SDG&E 9/14/11 Response
A. 10-06-007 South Bay Substation Relocation Project PTC
Energy Division Data Request 08 Dated September 7, 2011
SDGE-ED-008: Questions 2-9

SDG&E October 3, 2011 Response
A. 10-06-007 South Bay Substation Relocation Project PTC
Energy Division Data Request 08 Dated September 7, 2011
SDGE-ED-008: Q 1

Figure 1: Detailed GIS Substation Project Components Map 2 of 3

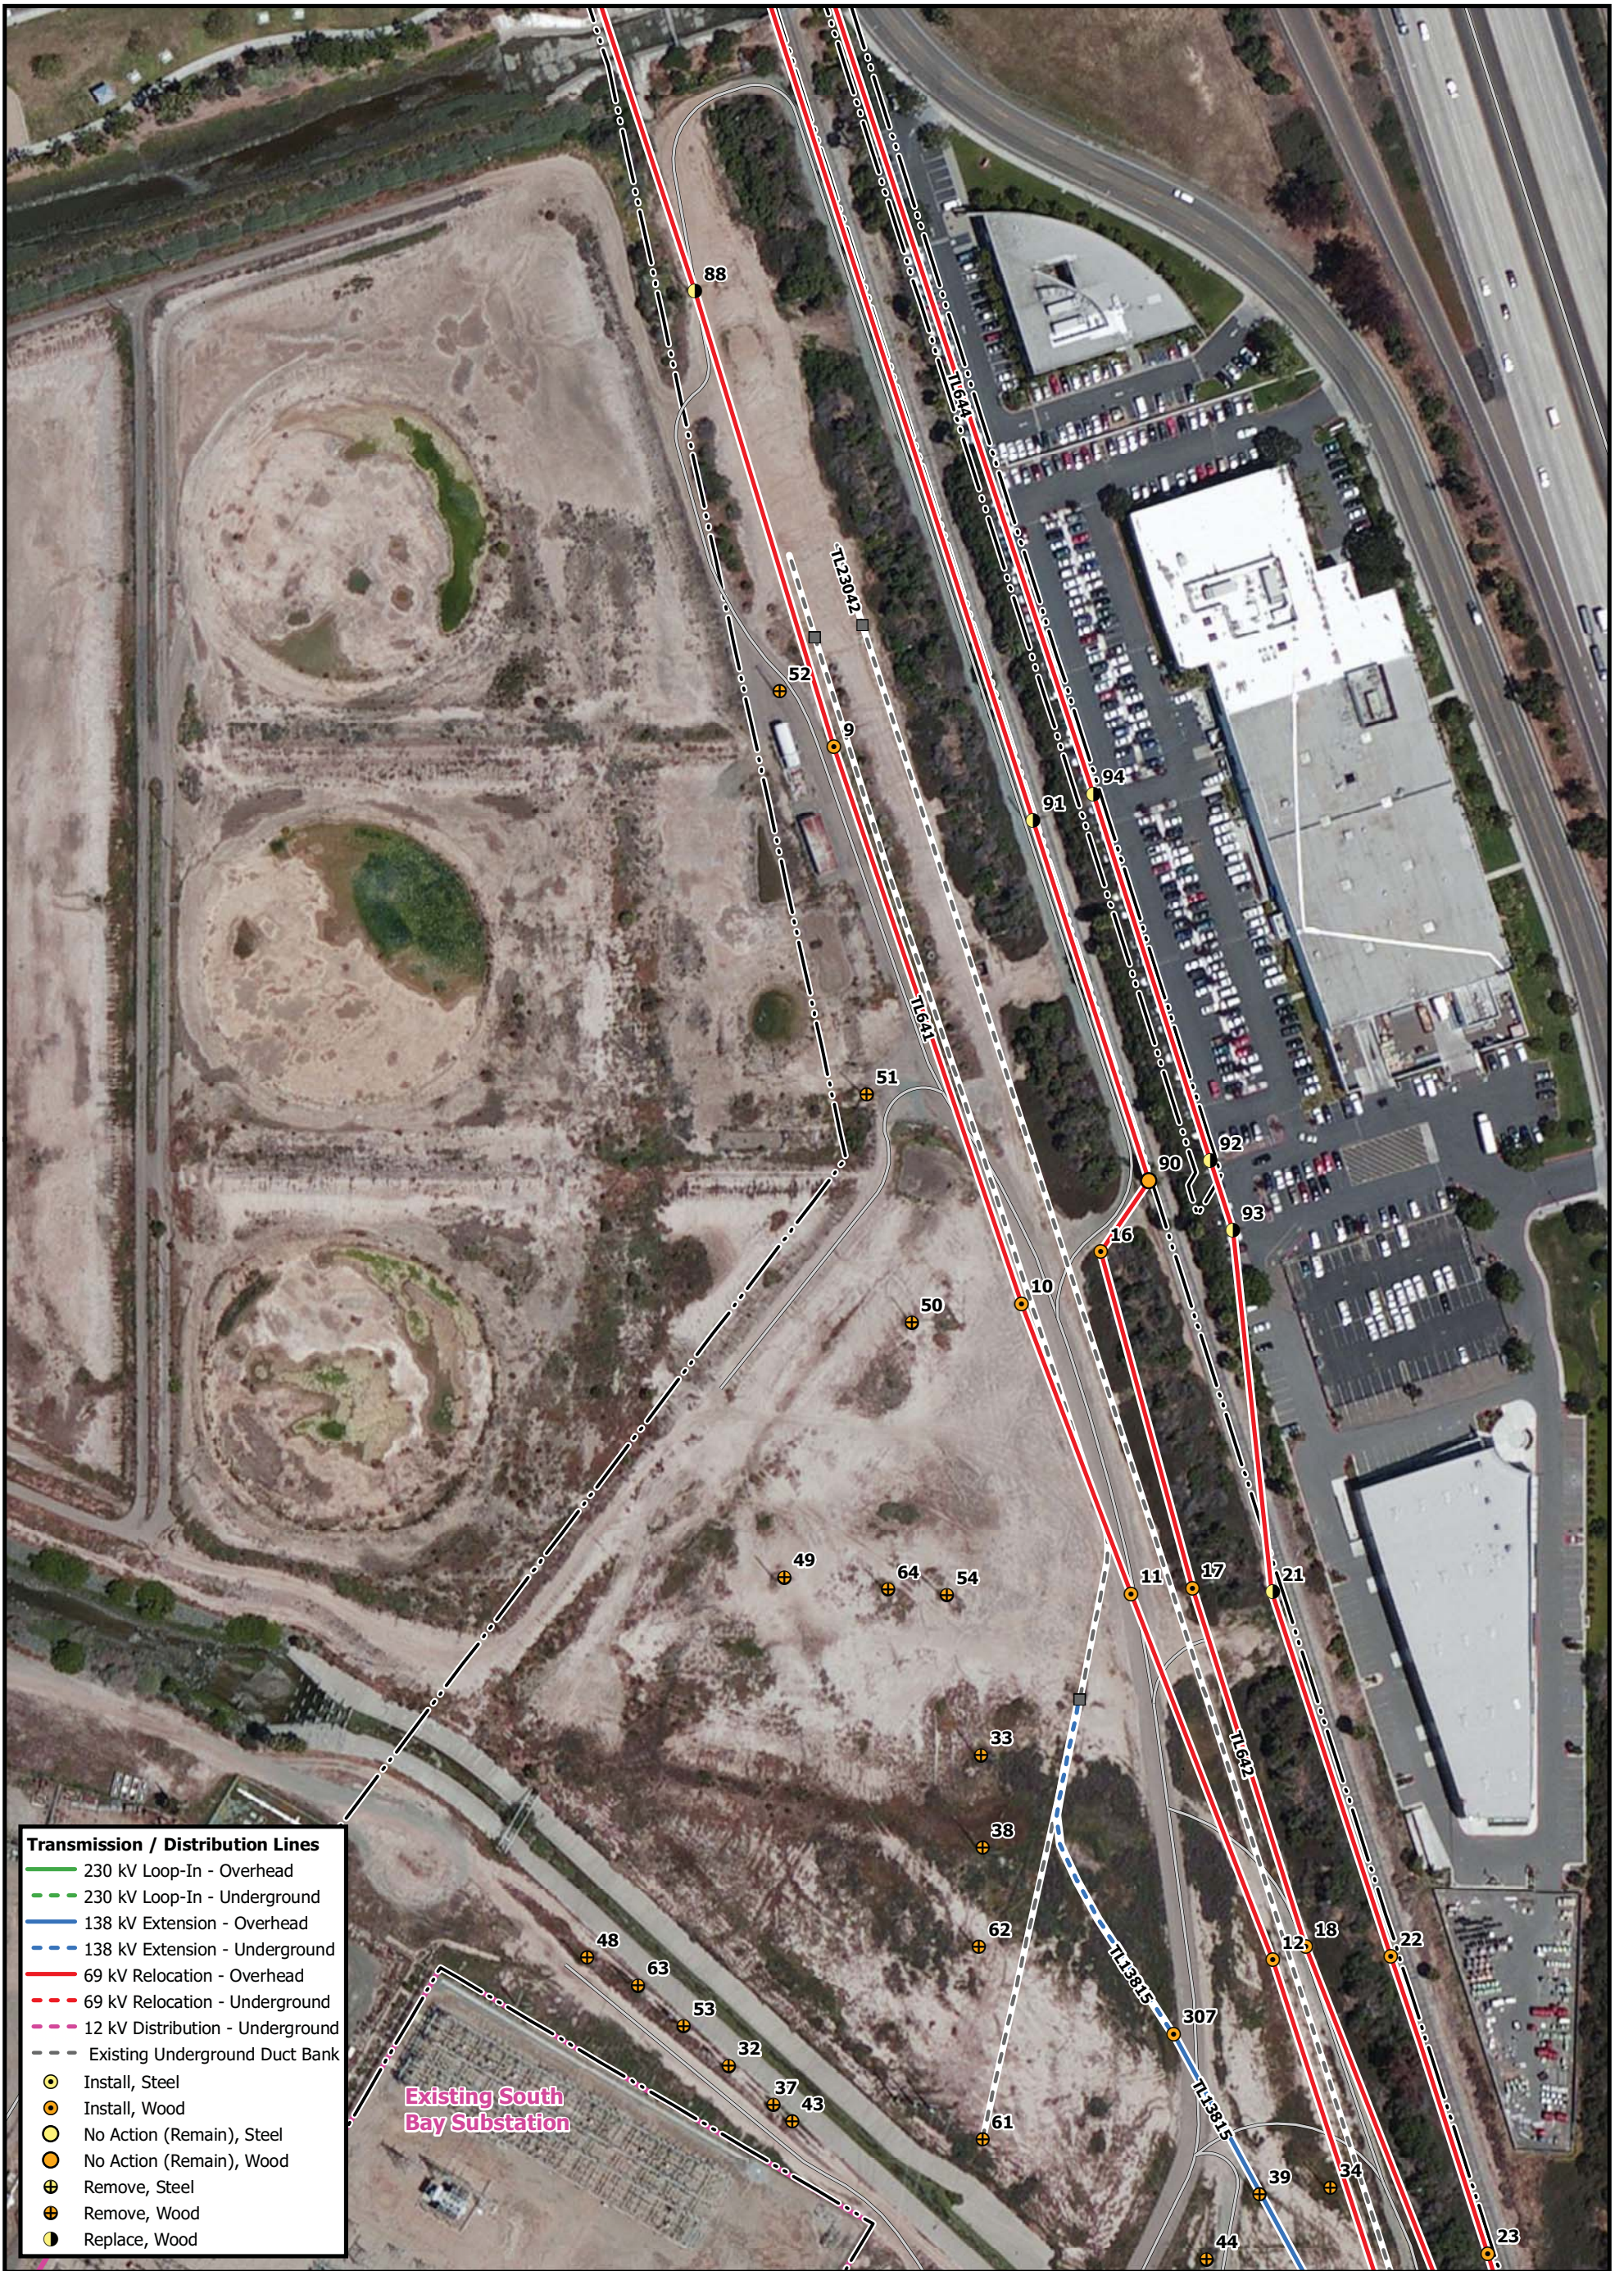
GIS Alternative: Section 2.1 of the GIS Substation Alternative Description and Preliminary Impact Analysis (May 2011) includes a description of the proposed transmission line interconnections that would be required with implementation of the GIS Substation Alternative. Please provide a map of the location of all transmission line interconnections that would be required with implementation of the GIS Substation Alternative. Please be sure to identify transmission infrastructure that would differ from the improvements identified under the Proposed Project (Air Insulated Substation).

Figure 1: Detailed GIS Substation Project Components Map provides the GIS substation footprint and the proposed 69 kV, 138 kV, and 230 kV transmission line configurations, including existing transmission pole locations, as well as those which would be removed, replaced, or installed. Figure 2: GIS Versus AIS Interconnection Comparison Map provides a side-by-side comparison of the proposed GIS and AIS substation footprints and their associated transmission line interconnections.
